# CITY OF ALBUQUERQUE STANDARD SPECIFICATIONS FOR PUBLIC WORKS CONSTRUCTION

## **UPDATE NUMBER 8**

## SUBJECT: UPDATE NO. 8 – REVISIONS, DELETIONS, AND ADDITIONS

Corrections and Changes to Update 8 January 2011 issued April 5, 2011

REVISIONS	WATER	AUTHORITY
	CONCRE	VATER TE BLOCKING JESIGN
	DWG. 2320	JANUARY 2011

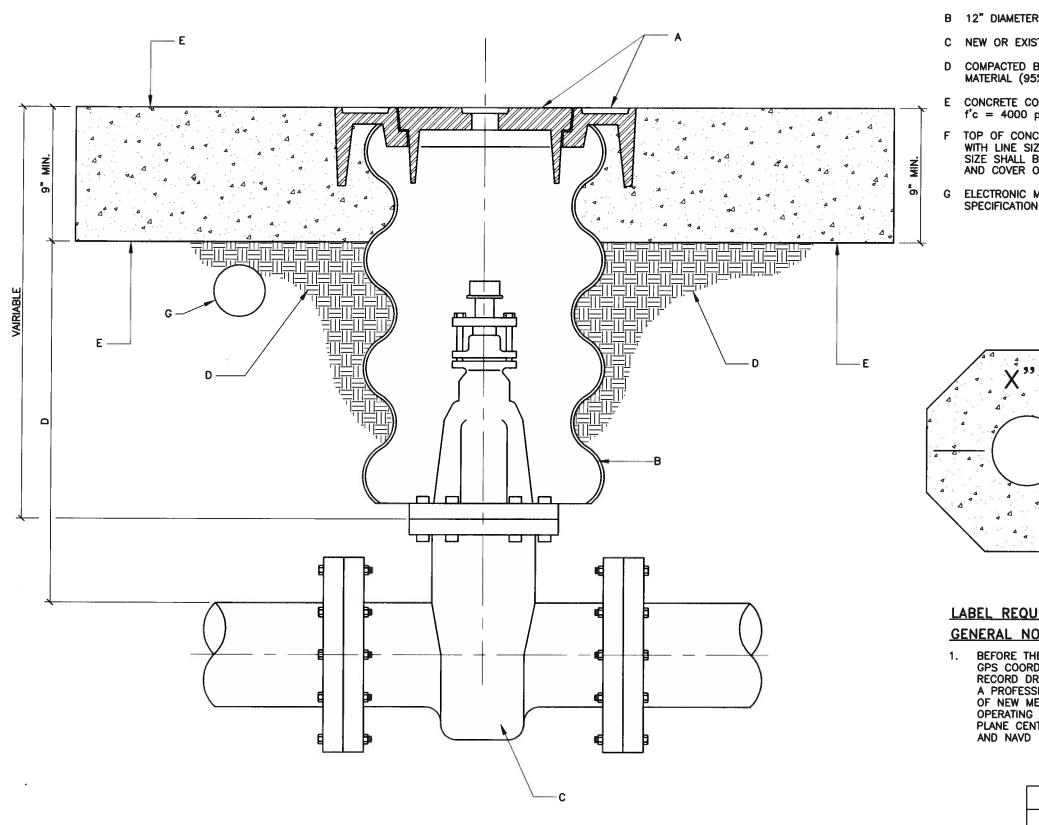
- 2315 Add note requiring 95% compaction;
- 2320 Add note for polyethylene liner; Add note for use of mechanical restraints;
- 2326 Revised to show EMD, 12" polymer coated cmp; 4,000 psi concrete collar, and GPS; Note added regarding GPS coordinate requirement;

REVISIONS	WATER AUTHORITY
	WATER
	RING AND COVER
	FOR VALVE BOX
	DWG. 2328 JANUARY 2011

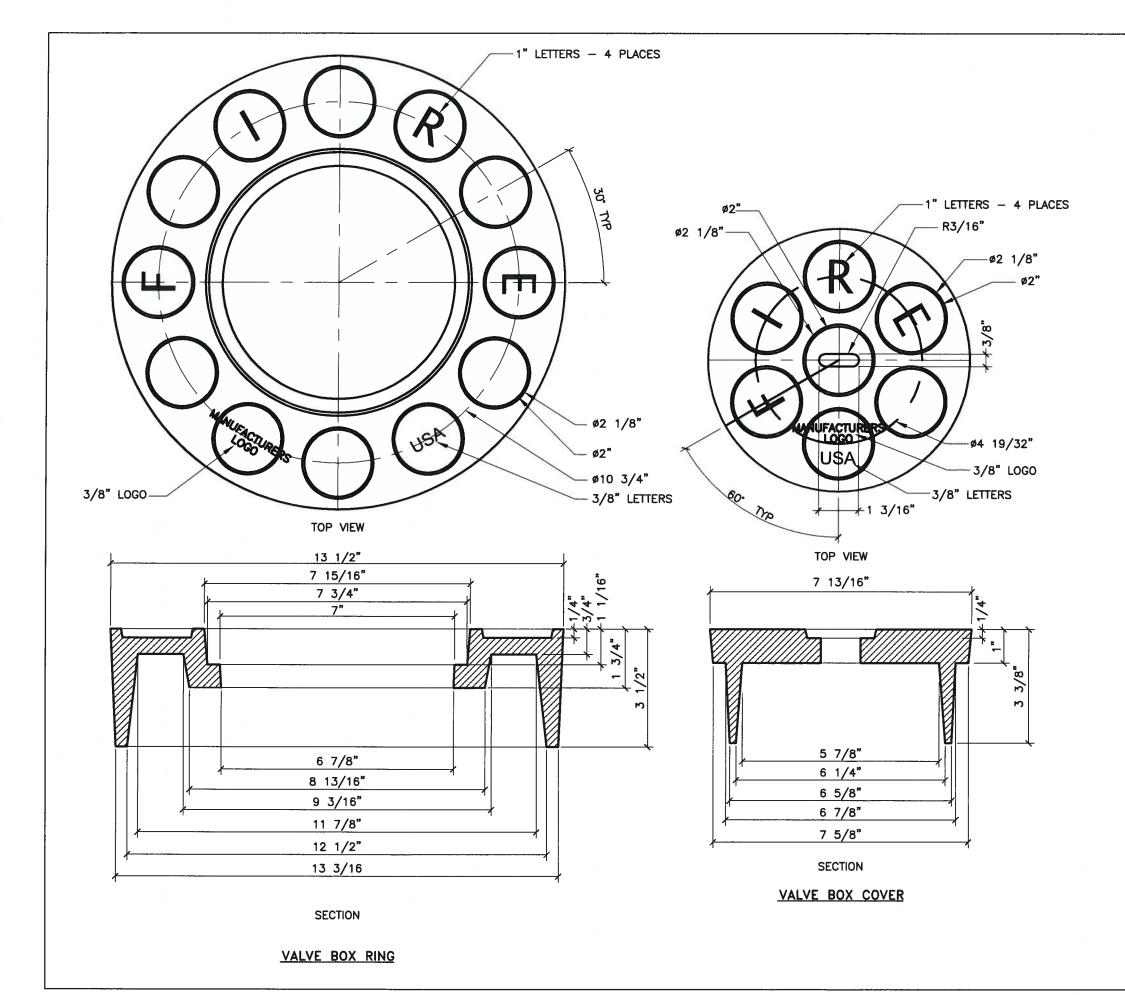
- 2328 Revised to show water on outside ring;
- 2329 NEW fire line ring & cover;
- 2333 Add note for restraint on both sides of valve; Add note anchor not needed for insertion that does not cut through the pipe; Note added regarding GPS coordinate requirement;

REVISIONS	WATER	WATER AUTHORITY			
	WATER				
	LADDER DETAIL				
	DWG. 2335 JANUARY 2011

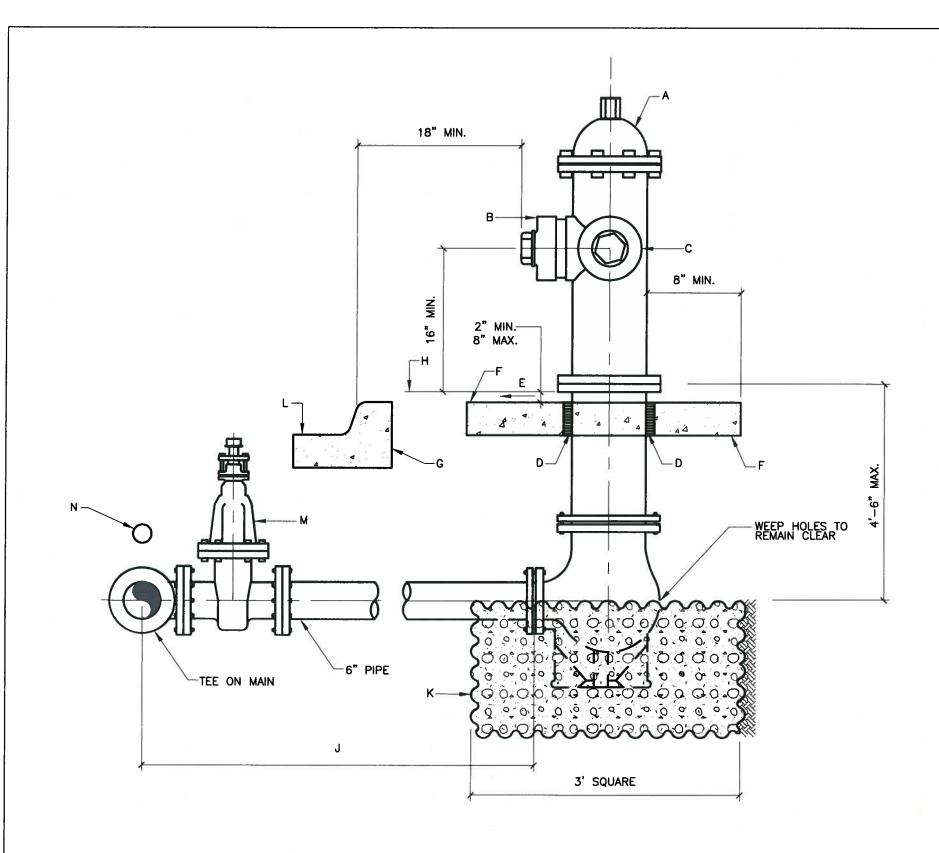
- 2334 Revised to show EMD, gooseneck with screen, pvc sleeve through manhole, and gravel;
- 2335 NEW ladder detail;
- 2340 EMD added to drawing; Note added regarding GPS coordinate requirement;

REVISIONS	WATER AUTHORITY	
	WATER AIR RELEASE FIRE HYDRANT CONNECTION	
	DWG. 2344 JANUARY 20	11

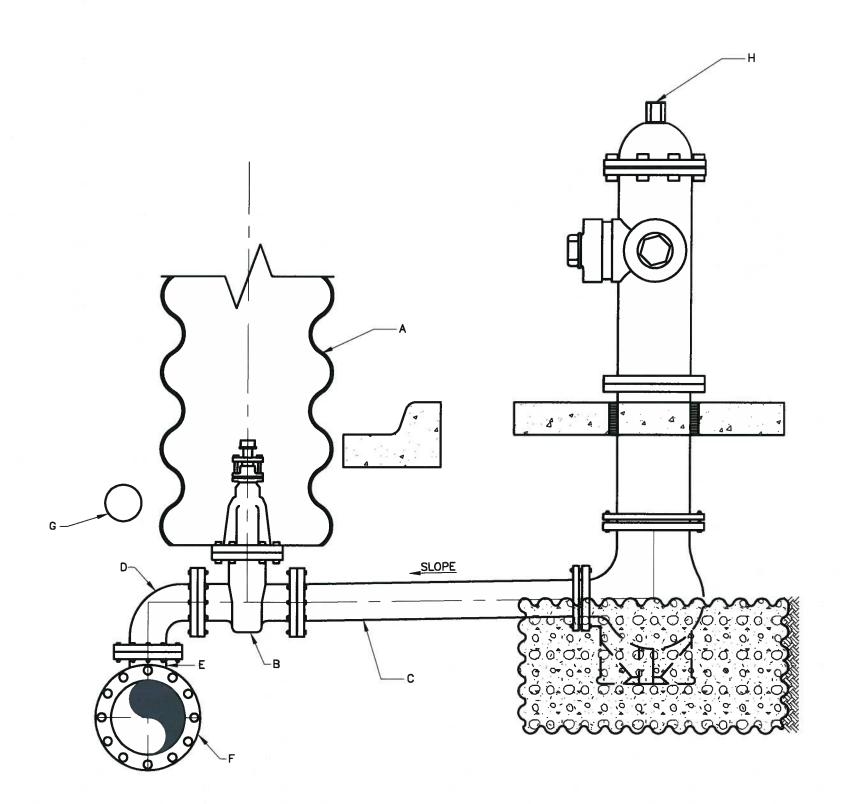
- 2344 Revised to show hydrant connection and EMD;
- 2350 Revised to show EMD; Add notes for Schedule 40 fittings; Add note to delete drain pockets when in water table;

REVISIONS	WATER AUTHORITY				
	٧	VATER			
		BUTTERFLY VALVE			
	DWG. 2352	JANUARY 2011

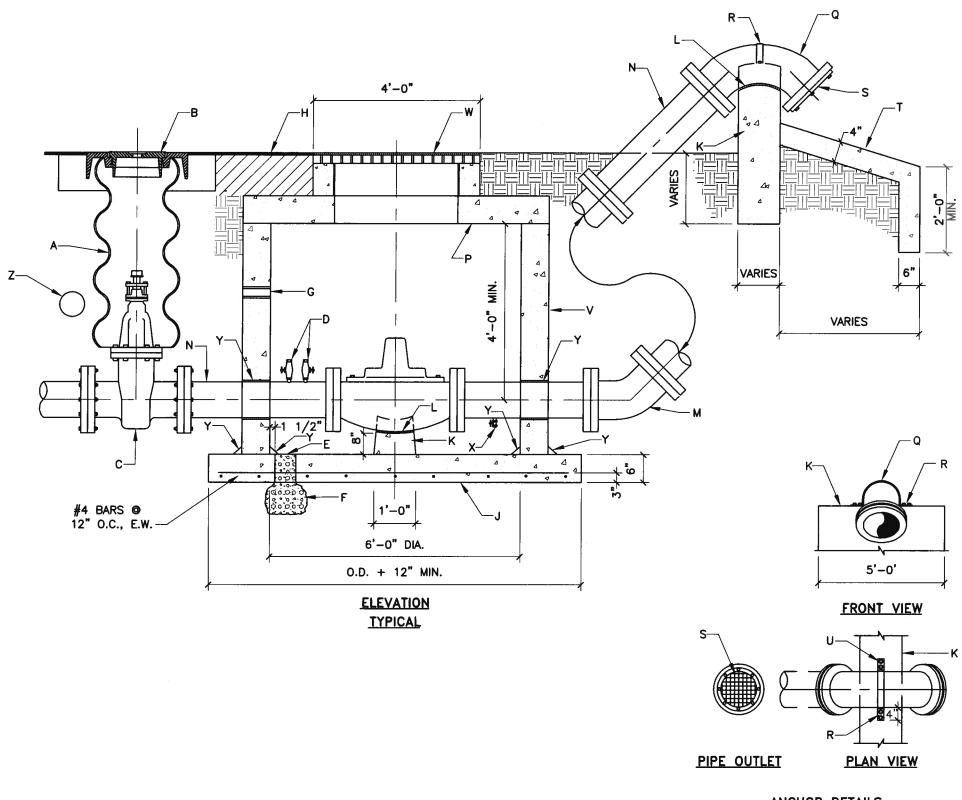
- 2351 Revised to show handwheel and operating nut profile;
- 2352 Revised to show handwheel and operating nut profile;
- 2353 Add several general notes (2-5,Z) regarding piping color, bollards, traffic, and drain pockets; addition of a note for EMDs;

REVISIONS	WATER	AUTHORITY	
	WATER DUCTILE IRON BUTTERFLY VALVE		
	DIRECT BURY IN	STALLATION DETAIL	L LS
	DWG. 2359	JANUARY 2011	ı

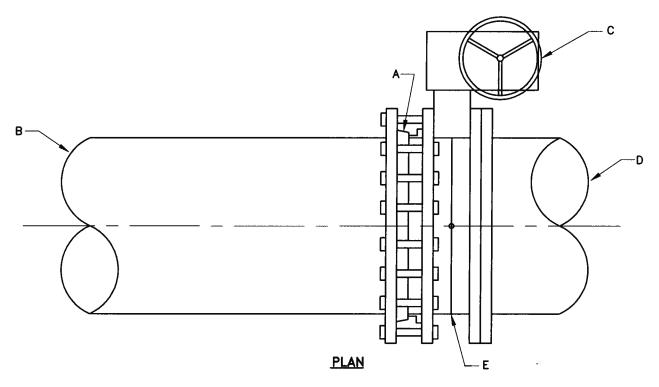
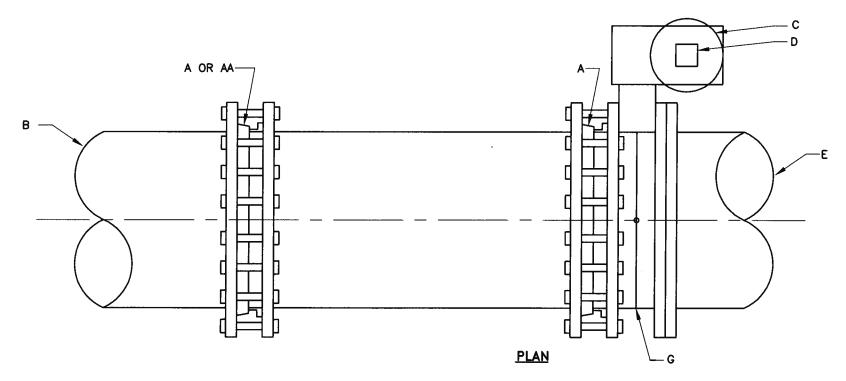
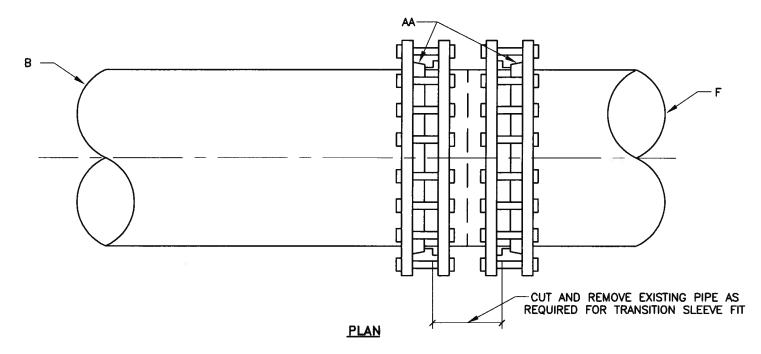
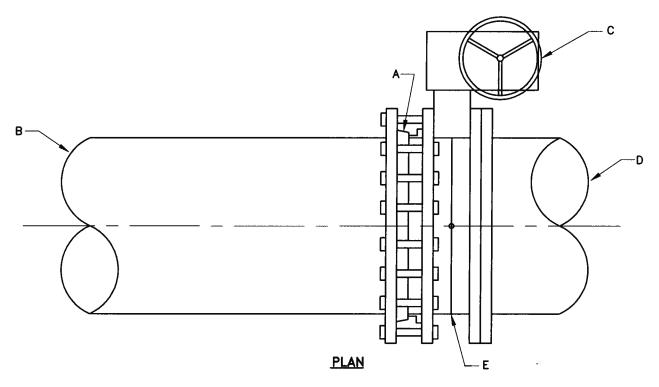
- 2354 Add several general notes (2-7) regarding piping color, traffic, bollards, vault parts, elevation plate requirement, and drain pockets;
- 2359 NEW butterfly valve for direct bury installation;

REVISIONS	WATER	AUTHORITY
	3/4" - 1"	MATER METER SERVICE STALLATION
	DWG. 2362	JANUARY 2011

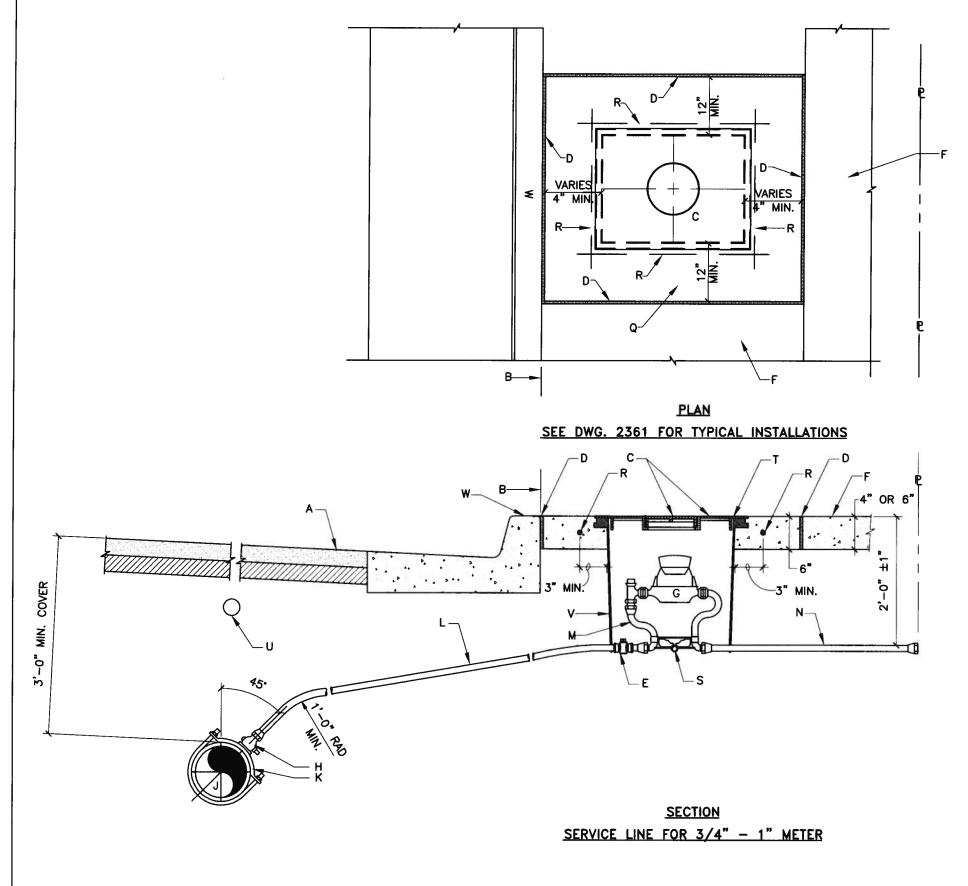
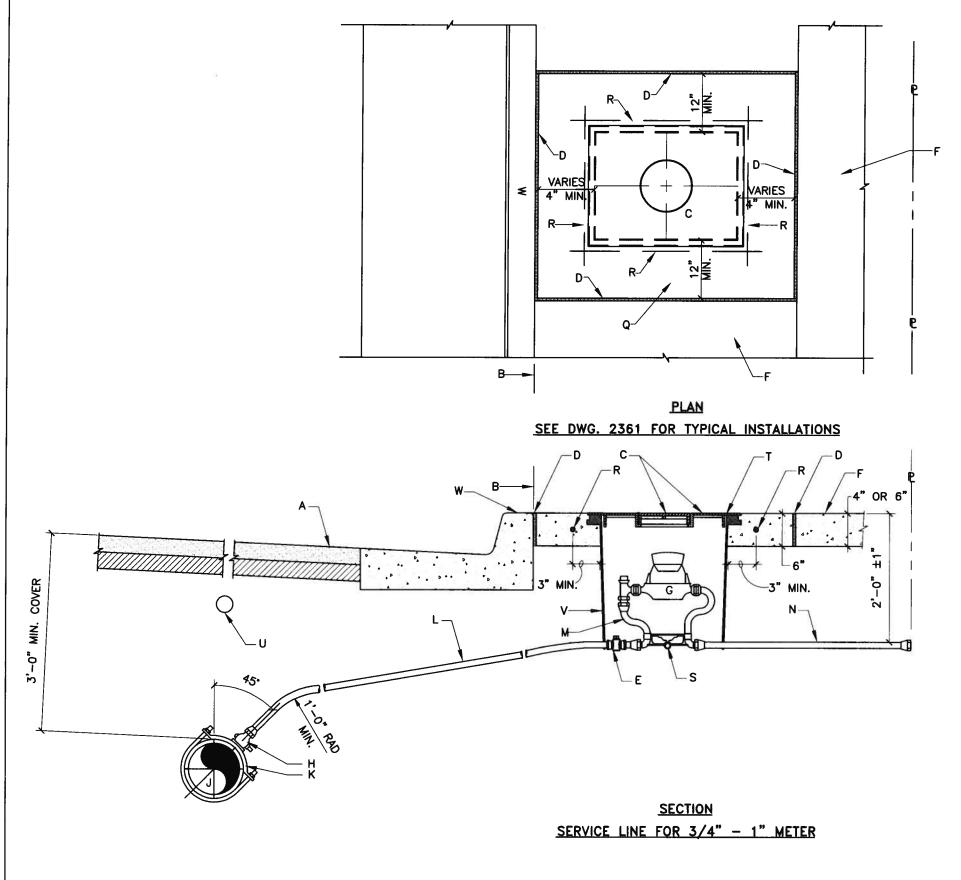
- 2360 NEW butterfly valve for in vault installation;
- 2362 The minimum width between the back of curb and the meter box is reduced to 4";
- 2363 Removal of notes 1, 2, 4, and 5 and add a note regarding the private tailpiece and construction notes U, V, and W;

REVISIONS	WATER	AUTHORITY
		WATER
	BORING	INSTALLATION
	DWG. 2380	JANUARY 2011

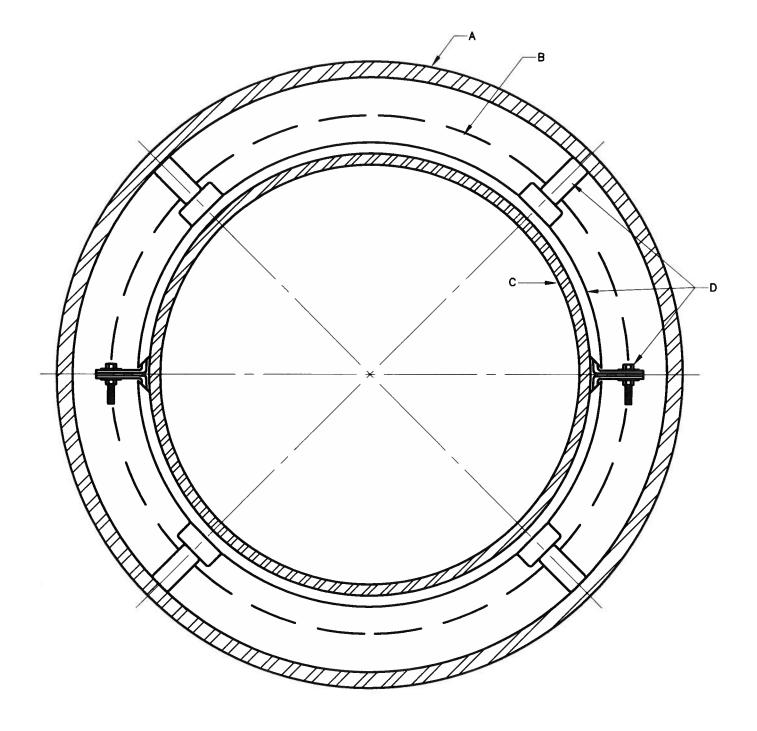
- 2374 NEW 10" PRV detail;
- 2380 Add general notes 2-3 regarding corrosion monitoring station requirement and pipe restraint;
- 2381 NEW line relocation detail;

REVISIONS		AUTHORITY
	MANHO	LE/VALVE
	CONCRETE O	COLLAR DETAIL
	DWG. 2461	JANUARY 2011

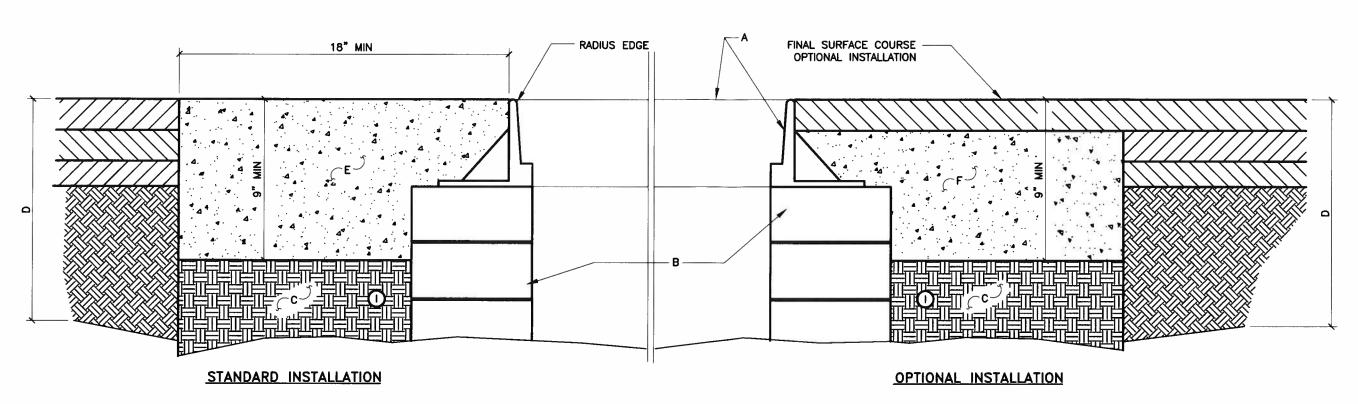
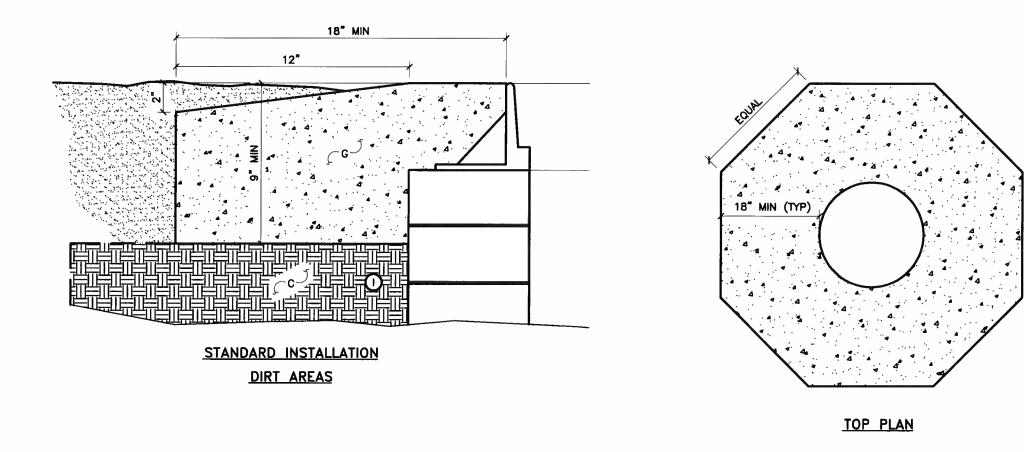
- 2109 NEW DI sas manhole frame and covers;
- 2110 NEW storm manhole frame and covers;
- 2460 Revised MH and Valve regarding: changes to show EMDs; Pavement not on top of collar;
- 2461 Collar detail to show EMD;
- 2301 Show old line removed rather than abandon in place; Note added regarding EMDs;
- 2310 NEW DI water manhole frame and cover;
